# AMS International (Sweaters) Ltd.

34 Choydana, P.O. National University Gazipur-1704  
(23°57'43.9"N 90°22'47.2"E)

26 APRIL 2014

Location plan showing required load reductions

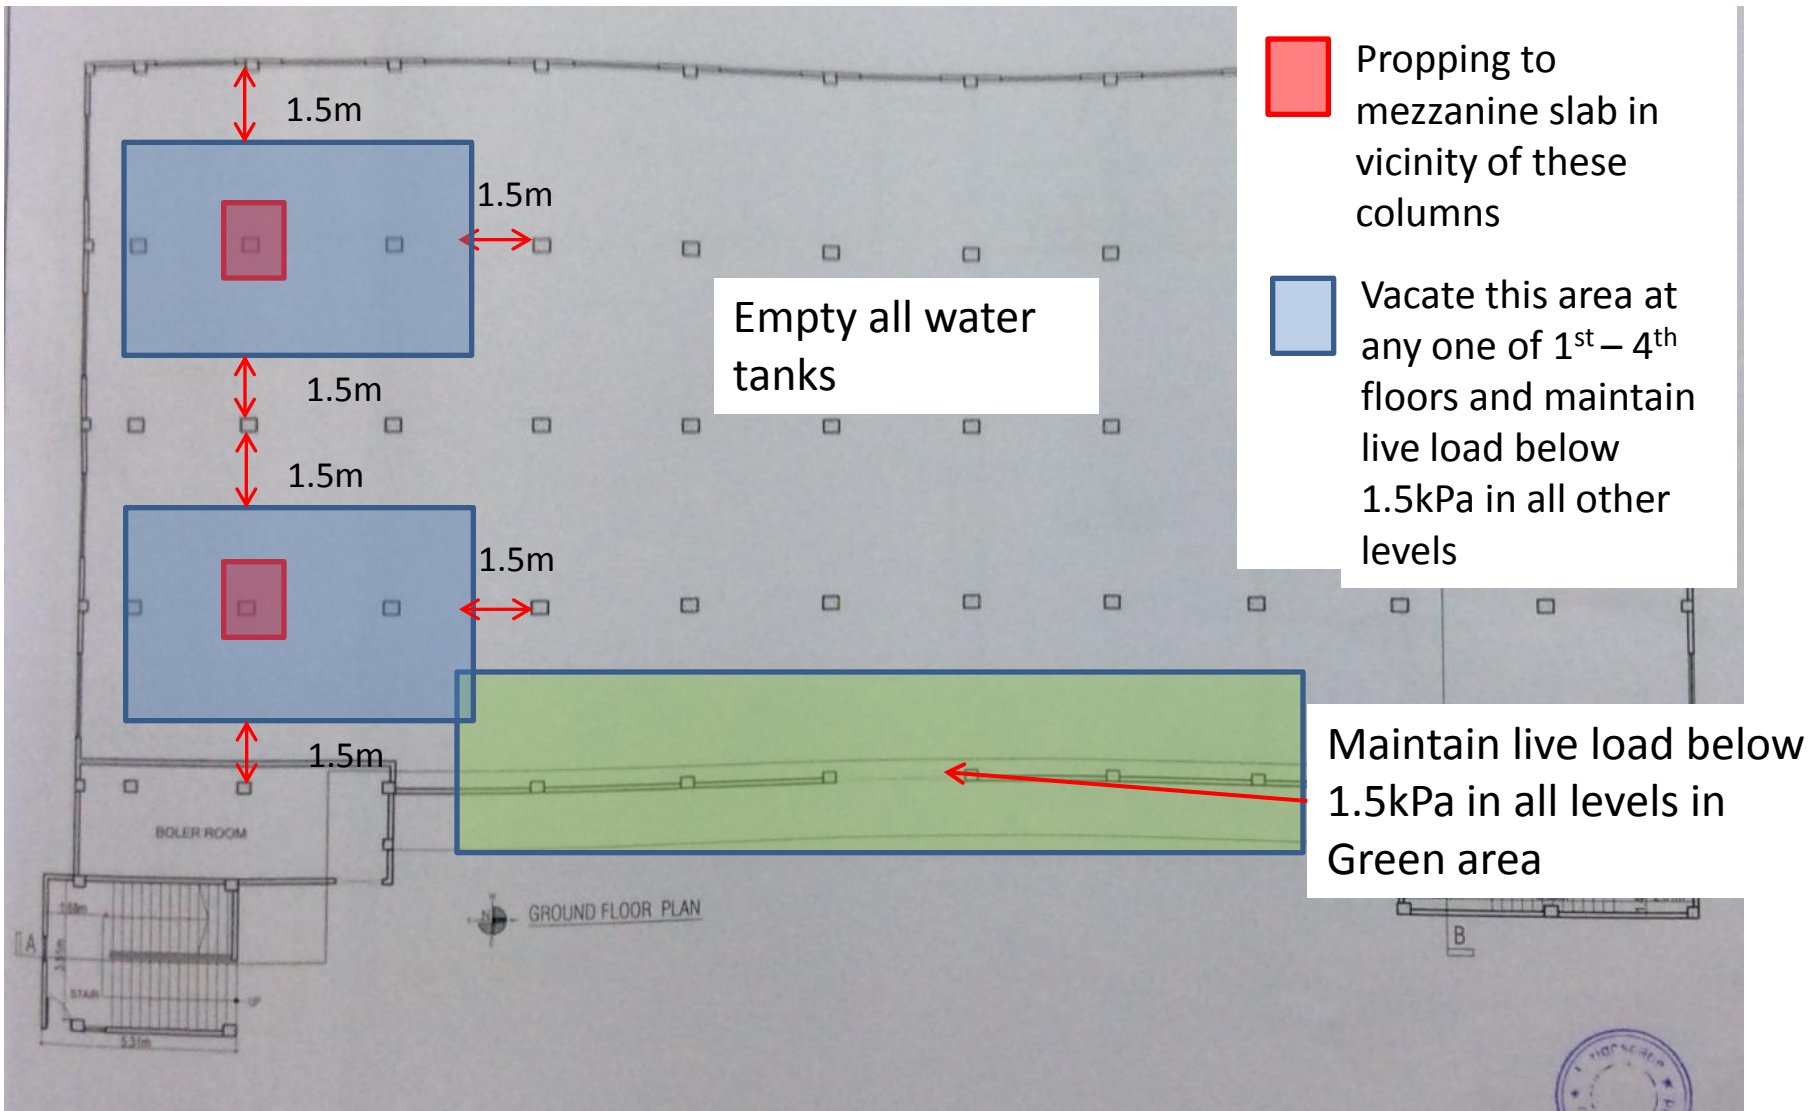
**We do have important and urgent concerns in relation to the adequacy of the structural columns.** Some columns appear to be stressed to levels that require immediate review. The following **immediate** actions are required to be carried out:

2. The areas highlighted on following page should be vacated at floors indicated and loads reduced to a maximum of 1.5kPa at all other levels
3. The mezzanine at ground floor should be propped down to the ground floor slab so it does not load the columns in question. The Building Engineer should determine the location and number of props required.

- **Immediately relocate water tanks to a suitable location (to be confirmed by Building Engineer) and vacate areas highlighted in blue at any one of 1<sup>st</sup> to 4<sup>th</sup> floors**
- **Immediately prop mezzanine at ground floor around columns highlighted in red above (prop size and location to be confirmed by Building Engineer)**
- Building Engineer to review design, loads and columns stresses in all columns.
- Verify insitu concrete strengths either by 100mm diameter cores or existing cylinder strength data for cores from min. 4 columns.
- A Detail Engineering Assessment of Factory to be commenced, see attached Scope.

# Undocumented additional steel structure

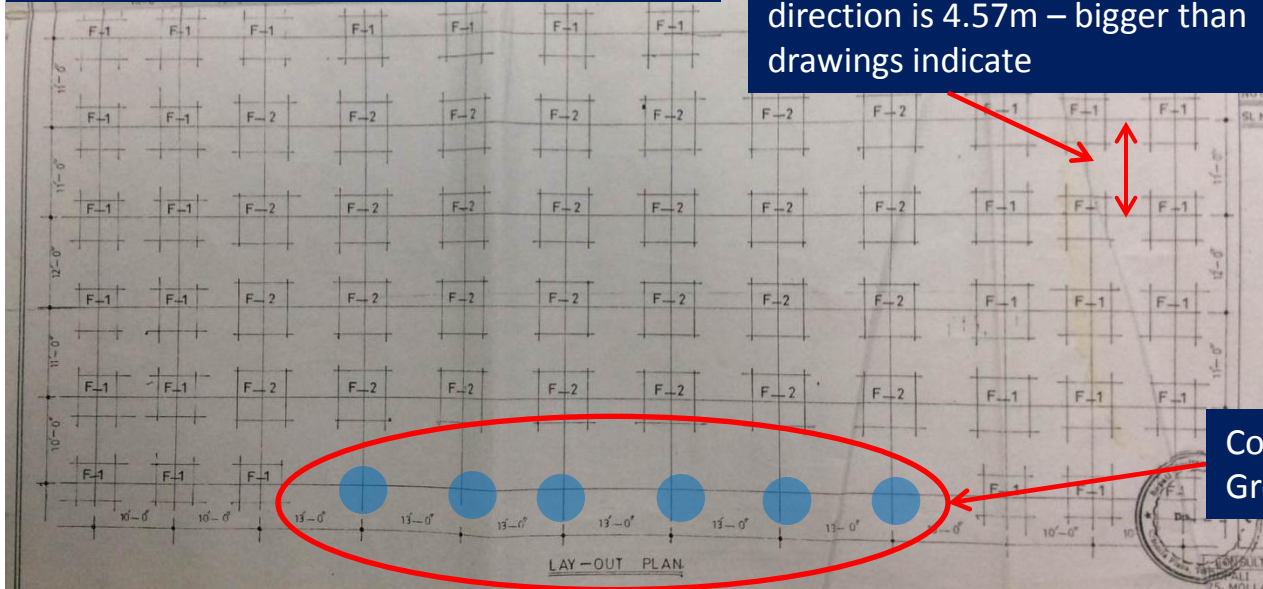
Building Permit for Building is for 5 storeys - the steel structure is not in scope of permit.  
Non-engineered lightweight steel roof addition does not appear to be strong enough to withstand severe wind events, with limited lateral stability system

- Building Engineer to survey and prepare as-built drawings for additional structure as part of Detail Engineering Assessment (see Item 1).
- Building Engineer to carry out design checks on additional structure as part of Detail Engineering Assessment, in particular resistance to wind uplift, given the current connection details

- Carry out any upgrade measures required as part of the design checks or remove structure

Floor plan on structural drawing (undated )

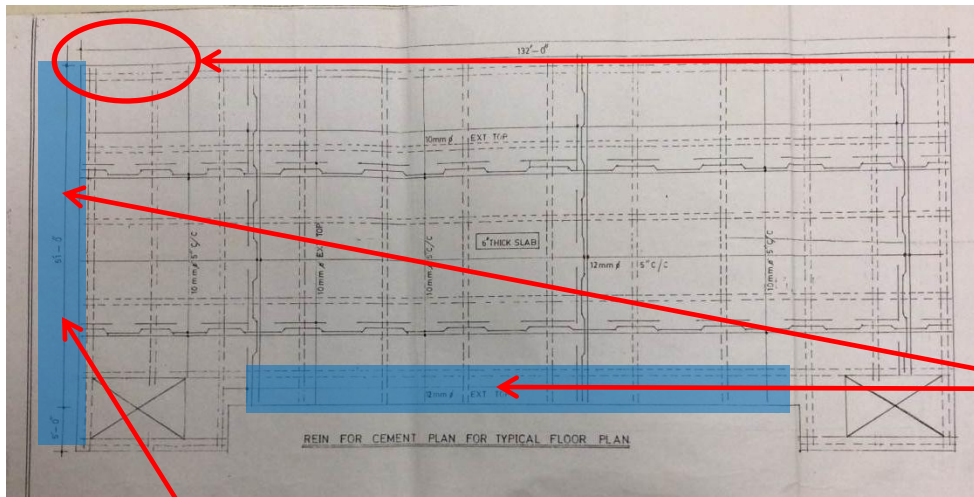
Typical grid spacing in this direction is 4.57m – bigger than drawings indicate

Columns in these locations from Ground to first not shown on drawing

Floor plans from permit, structural and as-built drawings do not fully reflect as-constructed building, as noted

- Building Engineer to carry out dimensioned as-built survey of the building
- Collect and produce accurate complete as-built drawings as part of Detail Engineering Assessment.

Extent of cantilever on south elevation (brick pier shaded)

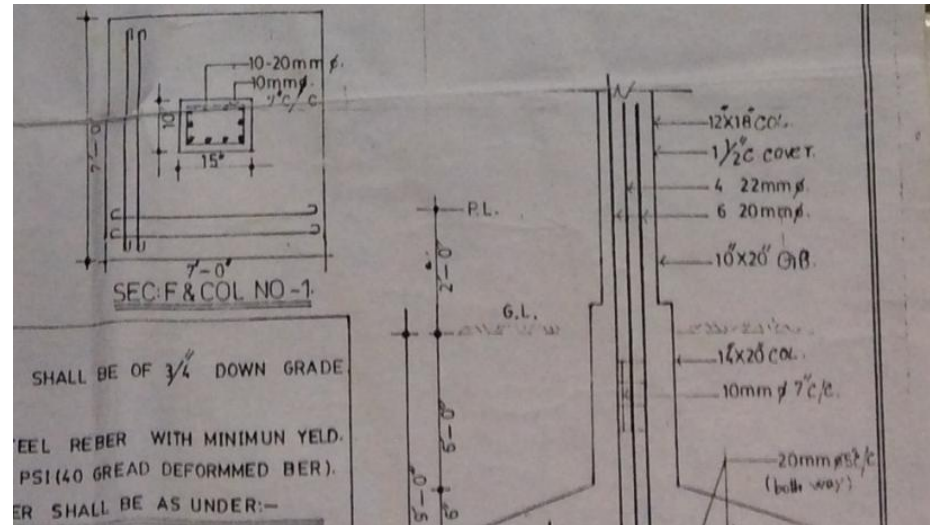
Perimeter structure is off grid in this area over full height of building

Slab cantilevers not shown or not shown accurately in areas indicated

# Inaccurate design documents

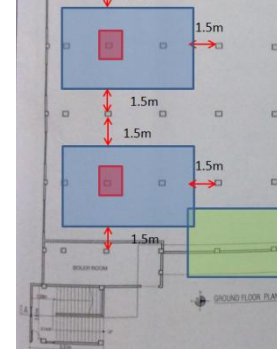
Columns are typically smaller than indicated on drawings.  
 Typical internal columns:  
 Specified: 300 x 450  
 Actual: 300 x 385
